W-6 UPPER SEGMENT: HWY 90 TO SW MILITARY DRIVE SEWER MAIN PROJECT

Solicitation Number: CO-00317

Job No.: 19-4519

ADDENDUM 1

PLOTTED BY: JAS
 DWG NAME: S31.SVD
 03/20/20 10:04 AM
 C:\Users\jasho\OneDrive\Bentley\Bentley\Projects\4190055\SAWS W-6 - RVT2 - jasho\jeng.com.rvt

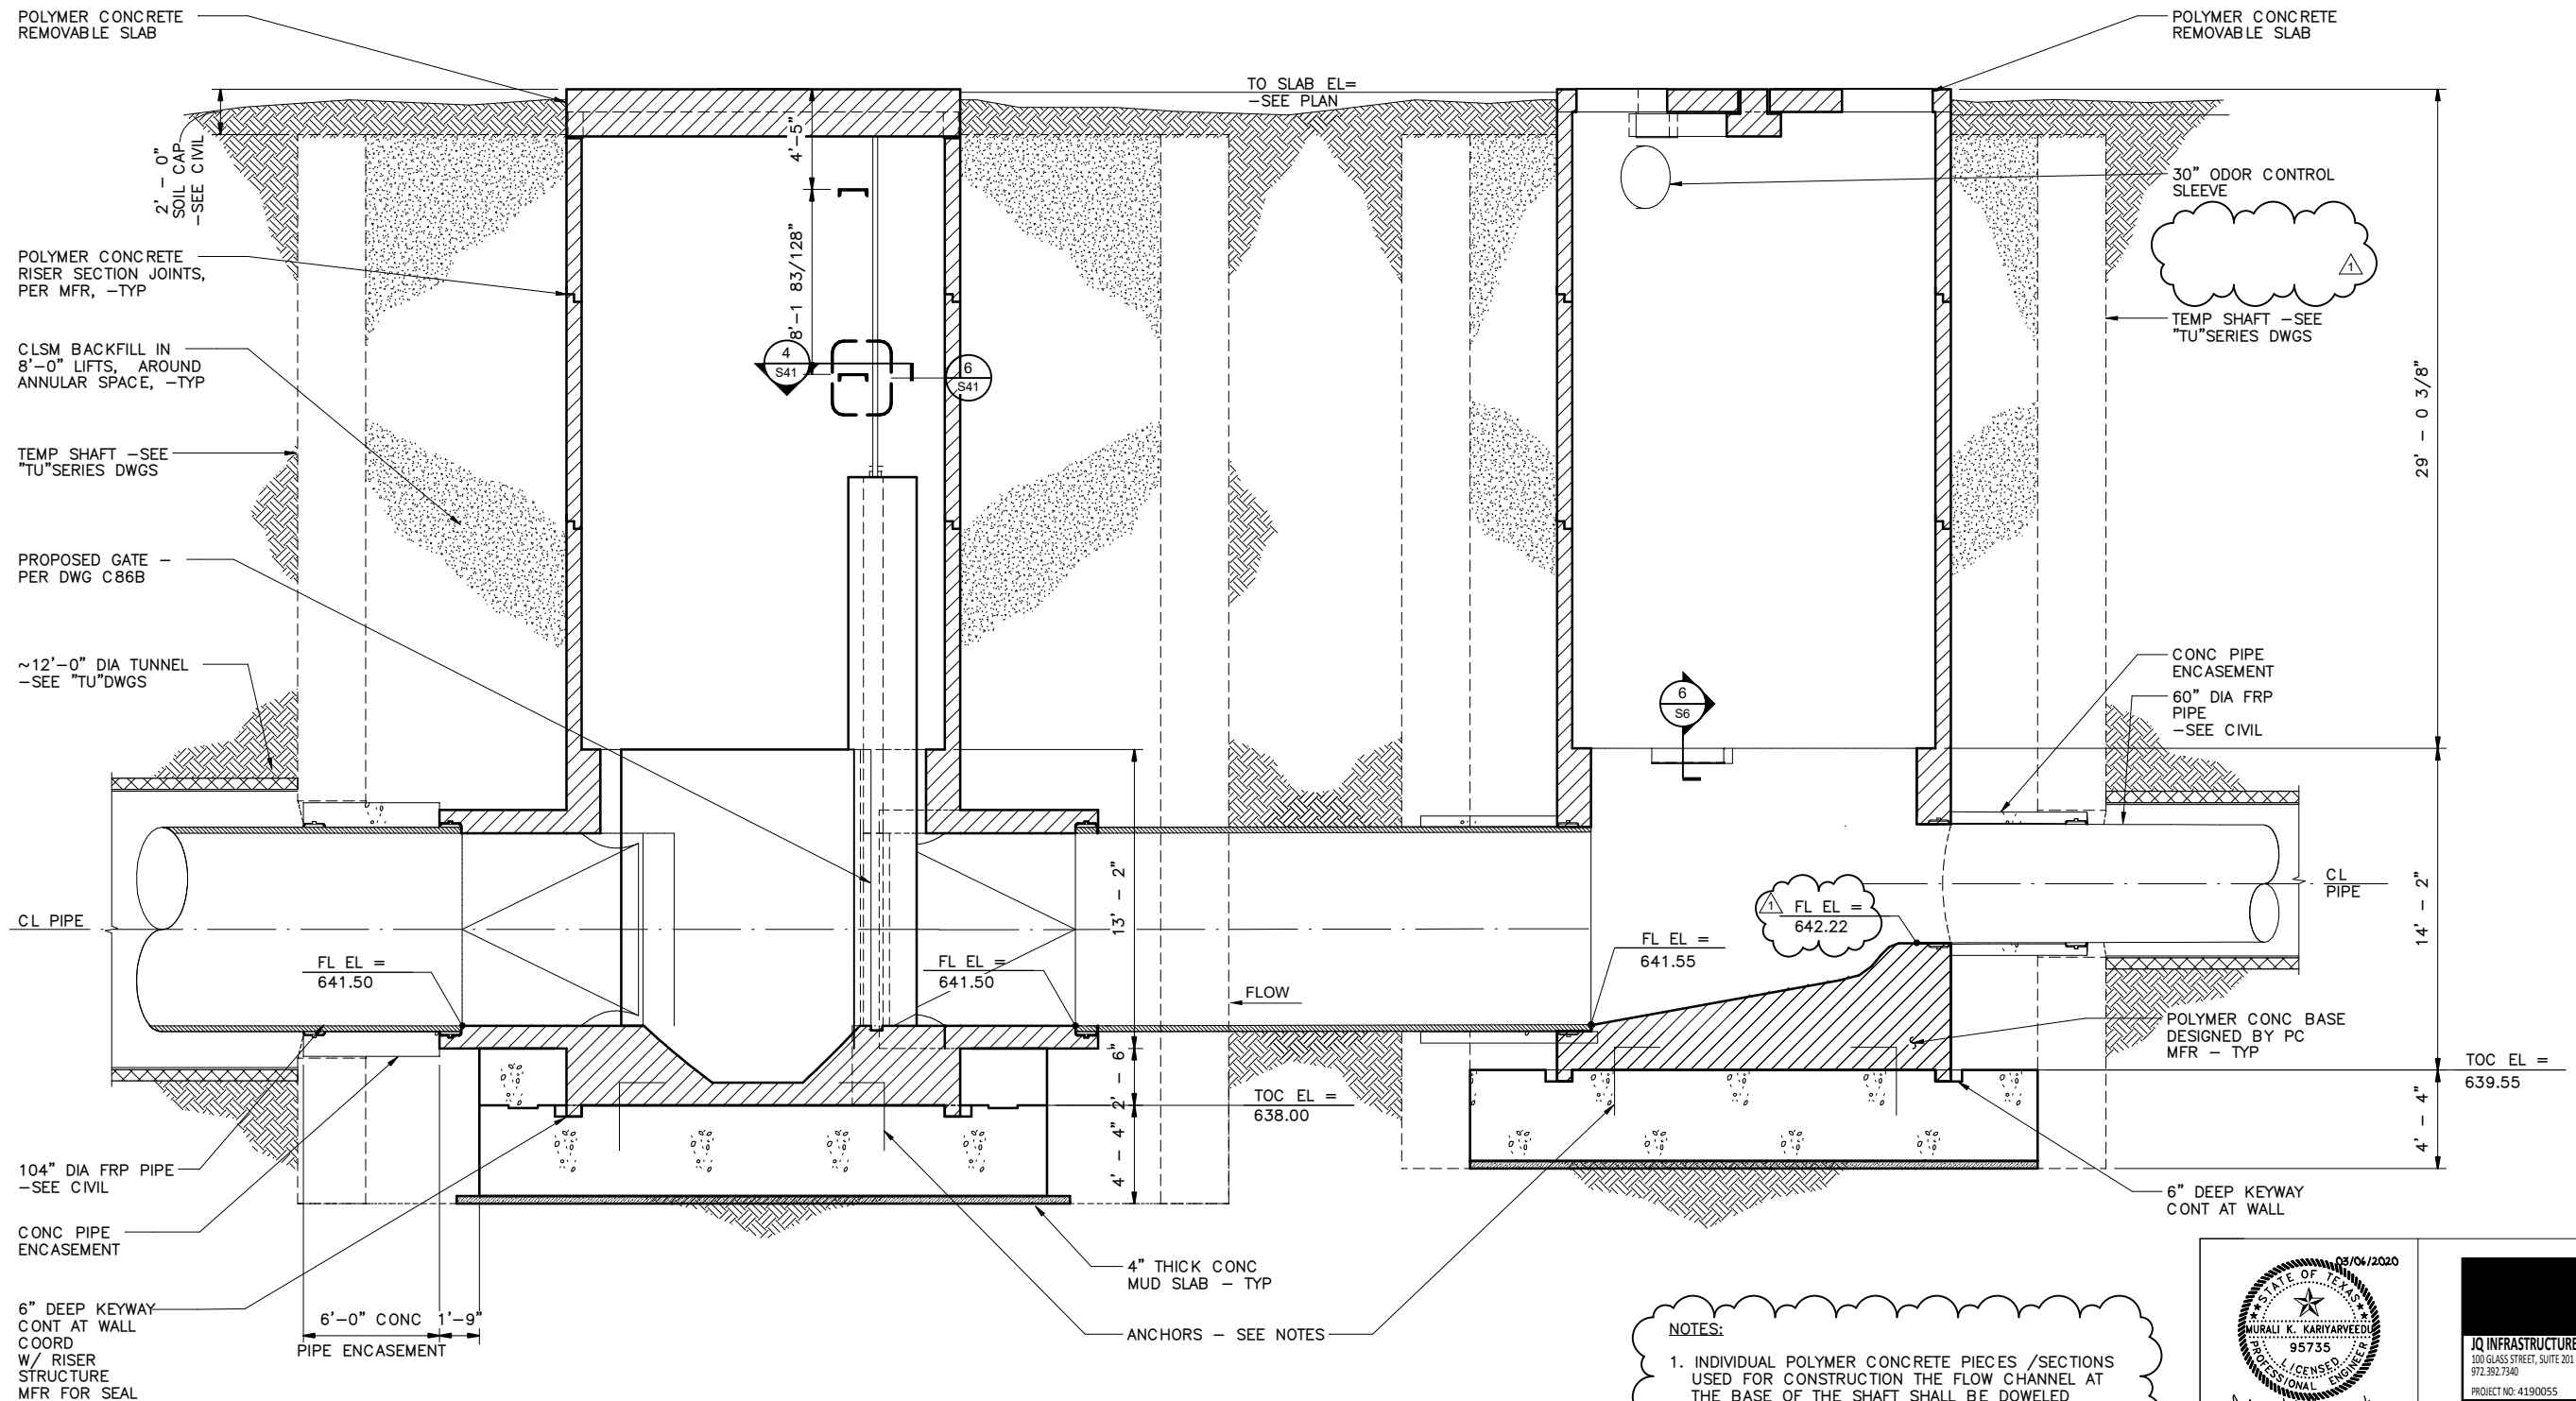
- Sheet S31 - SHAFT #5 (HOTEL SHAFT) - UPPER LEVEL SLAB PLAN AT EL 745.04’, -- Revise and replace sheet in its entirety.
 - Revise Elevation callouts “EL 745.04” to the following: “EL 7747.33” at three locations.

**SHAFT #7 (W-1 CONNECTION SHAFT) - UPPER
LEVEL PLAN ANT EL 682.75'**

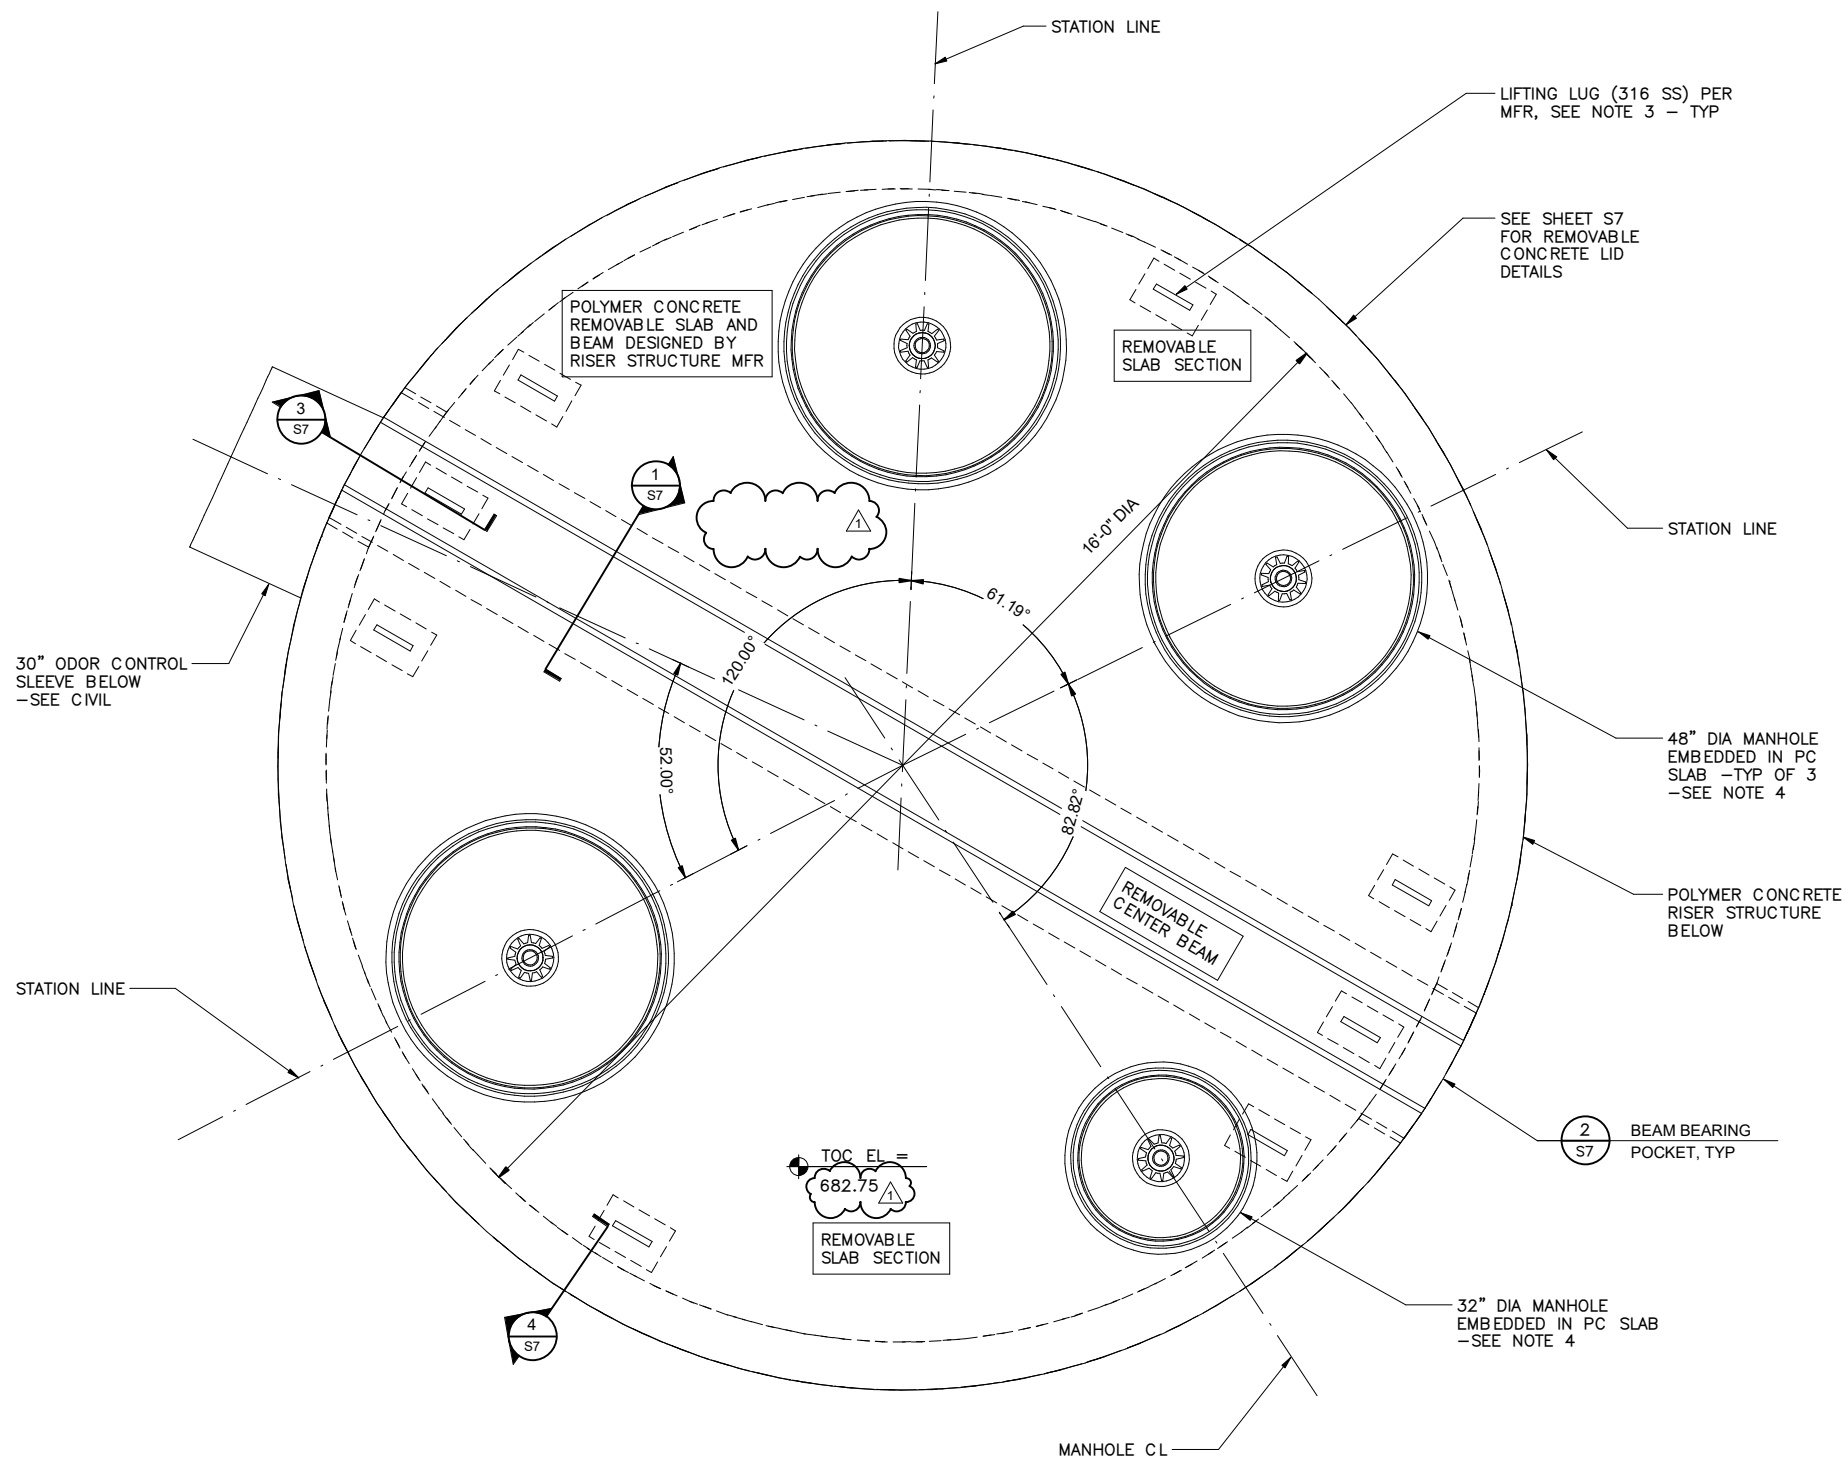
- Sheet S47 - SHAFT #7 (W-1 CONNECTION SHAFT) - UPPER LEVEL SLAB PLAN AT EL 682.61', - Revise and replace sheet in its entirety.
 - Revise Elevation callouts "EL 682.61" with the following: "EL 682.75" at three locations

- Delete note for thickness of slab at one location.
- Sheet S49 - SHAFT #7 (W-1 CONNECTION SHAFT) - ENLARGED SECTION I, - Revise and replace the sheet in its entirety.

PLOTTED BY: JGJ
 DWG NAME: S52.SVD
 3/20/20 10:09 AM
 C:\Users\jgja\OneDrive\Documents\19-010005-SAWS W.s. - RVT\JGJ\jgeng.com.rvt

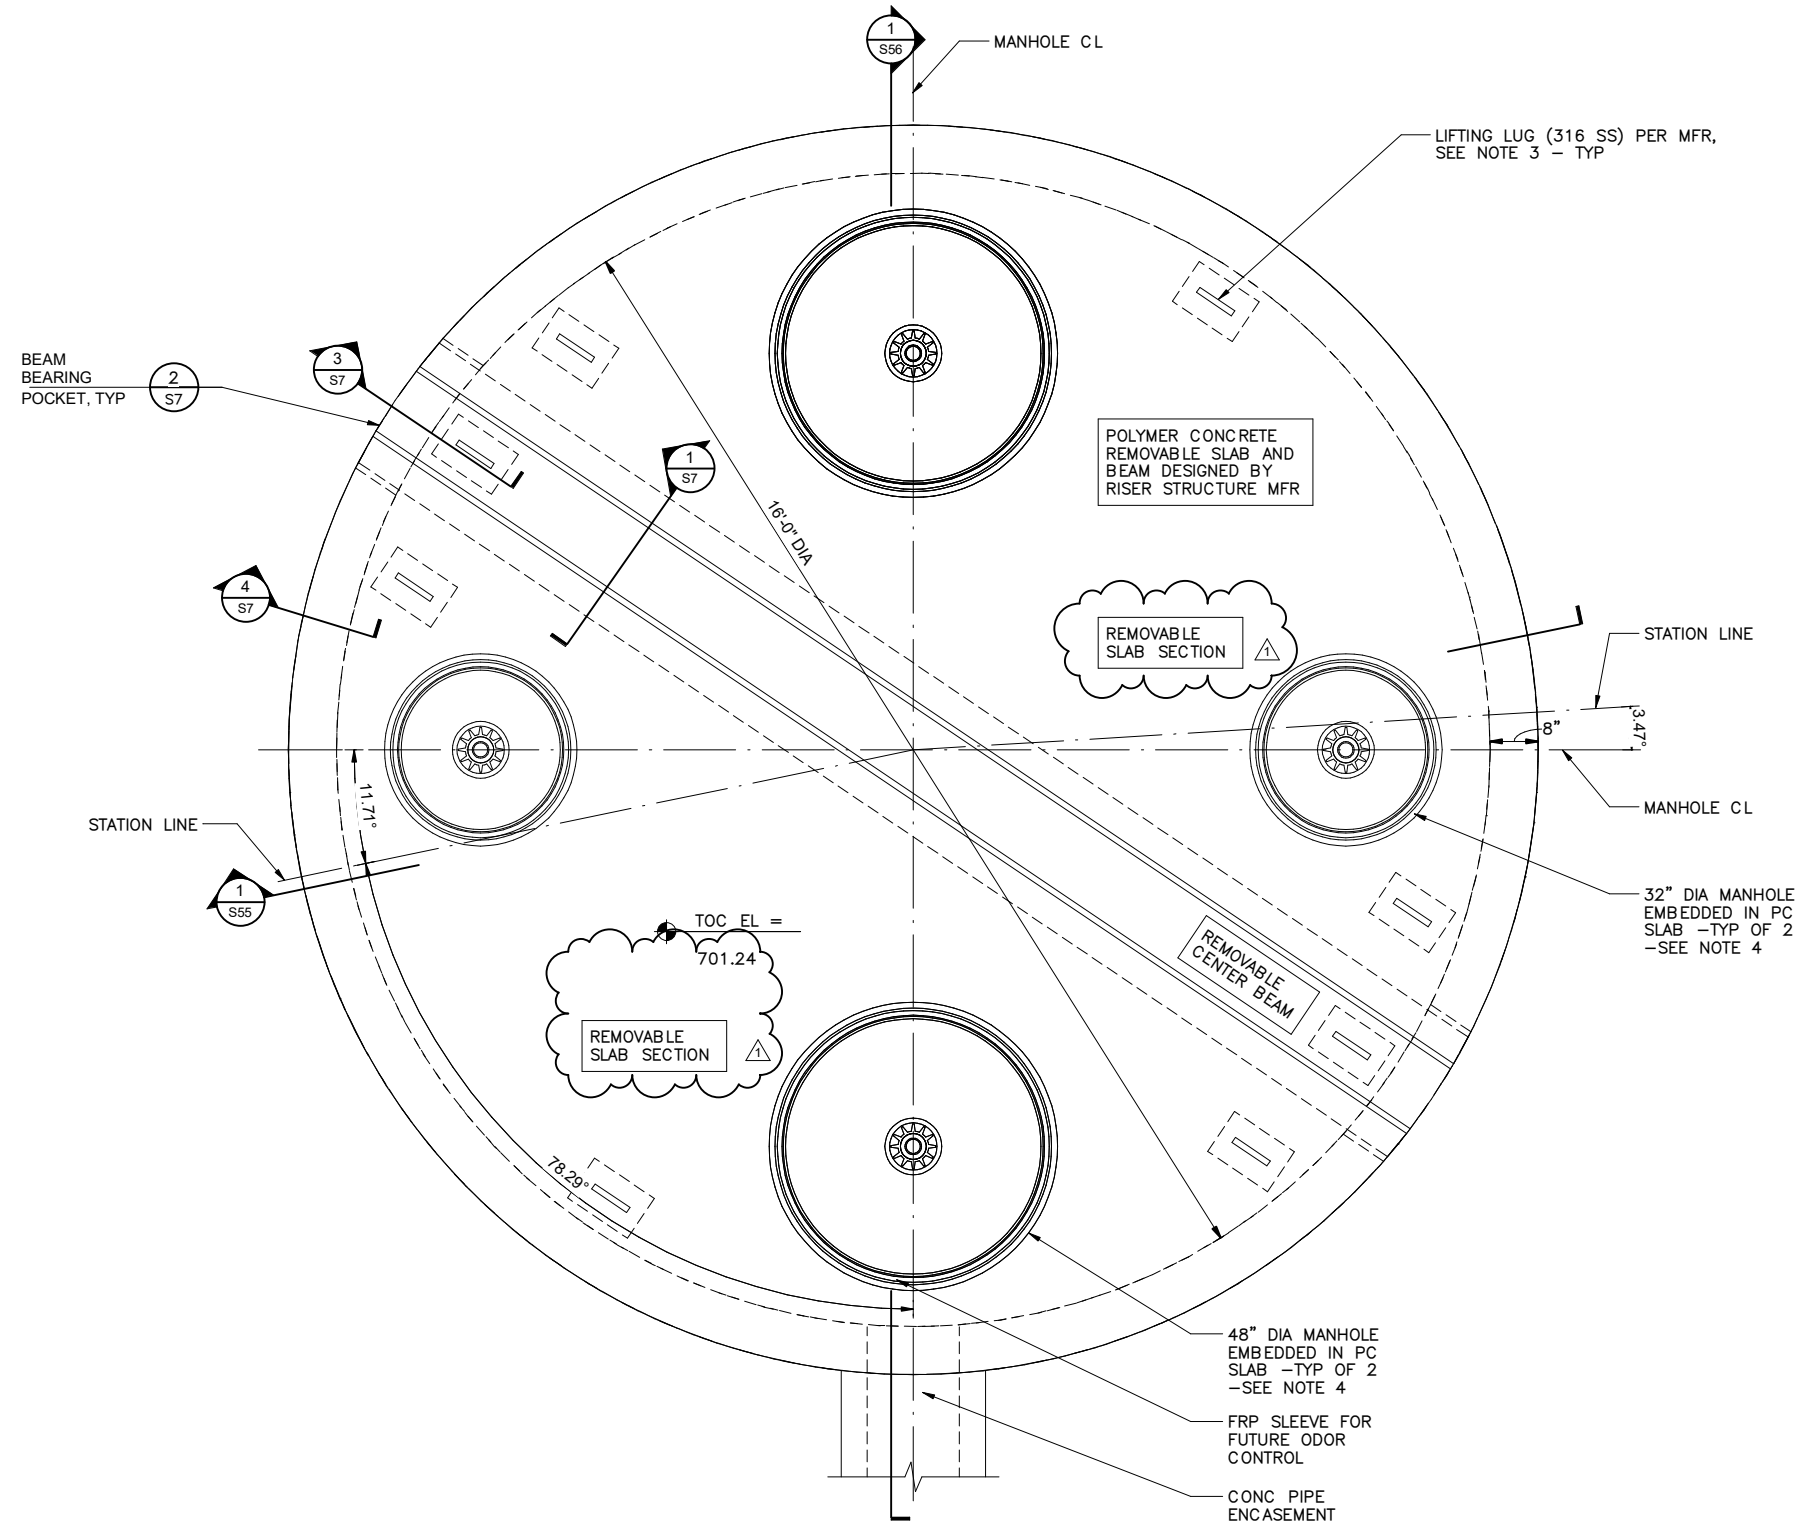
- Sheet S52 - SHAFT #8 (BALLPARK SHAFT) - LOWER LEVEL PLAN AT EL 657.48', - Revise and replace sheet in its entirety.
 - Add note for radiused smooth edges at the flow channel.

DATE: FEBRUARY 2020	SAWS PROJECT NO.	SHEET NO. S55
DESIGN: CD	KHA PROJECT NO.	
DRAWN: LAS	068665052	
CHECKED: MK

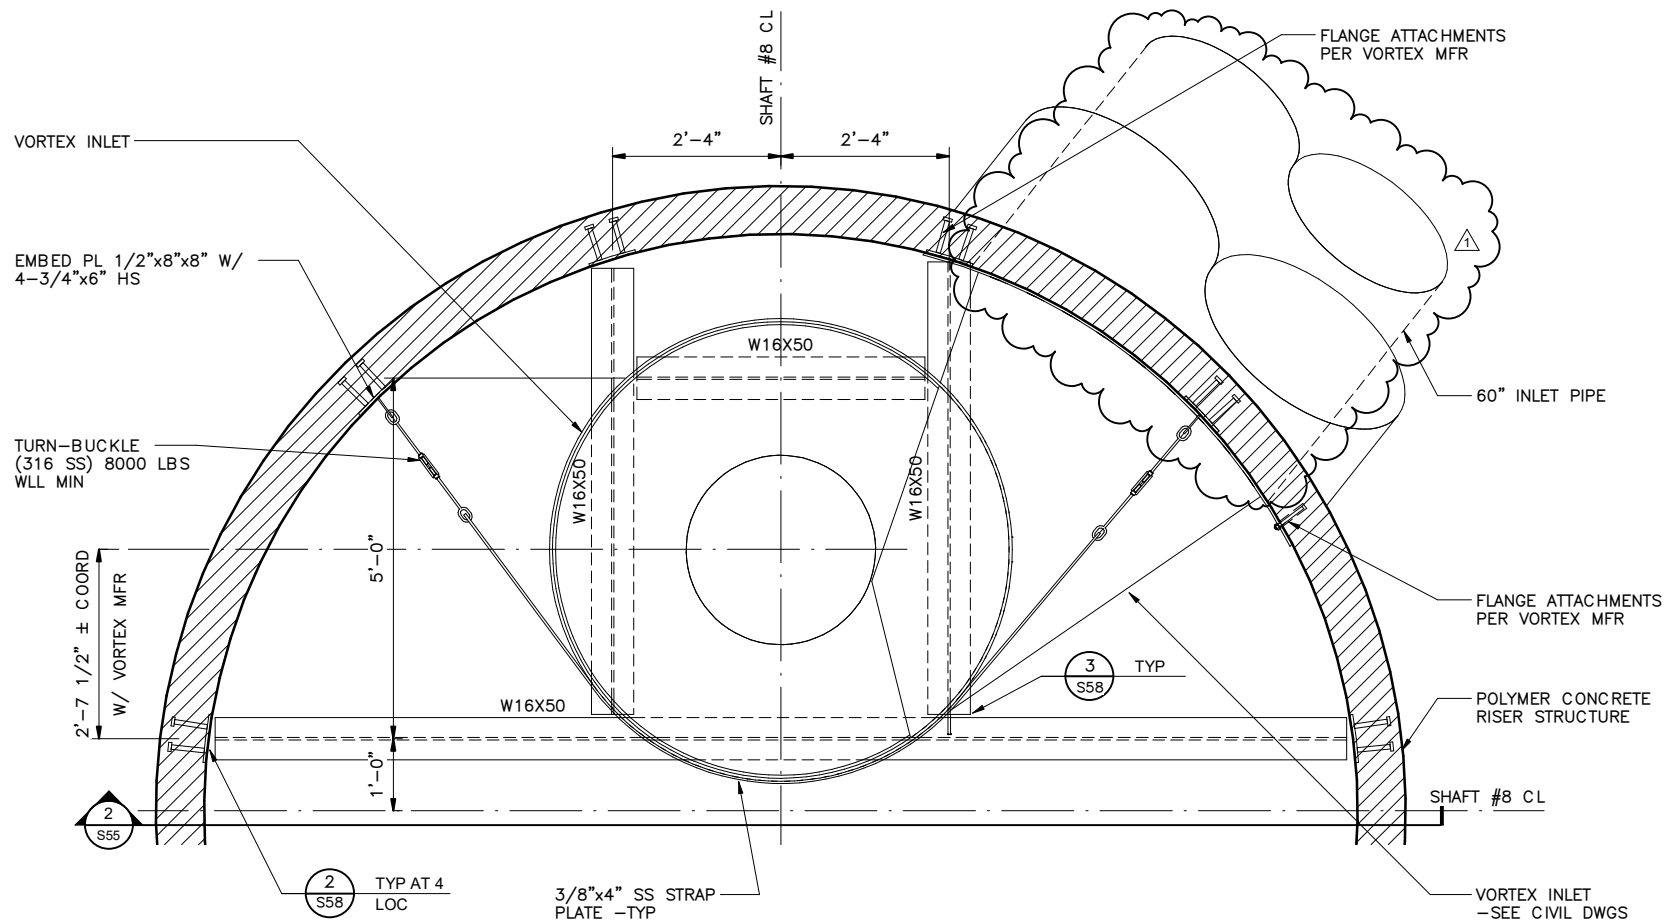
- Sheet S55 - SHAFT #8 (BALLPARK SHAFT) - SECTION I, - Revise and replace sheet in its entirety.
 - Revise note for embedded energy dissipator at the vortex drop as shown.

- Revise note No. and 1 and 2 as per attached drawings.
 - Revise shaft depth as shown
- Sheet S56 - SHAFT #8 (BALLPARK SHAFT) - SECTION II:
 - Add Straps to anchor 60-inch vortex drop pipe at two locations equally spaced and add the following callout for the Straps:
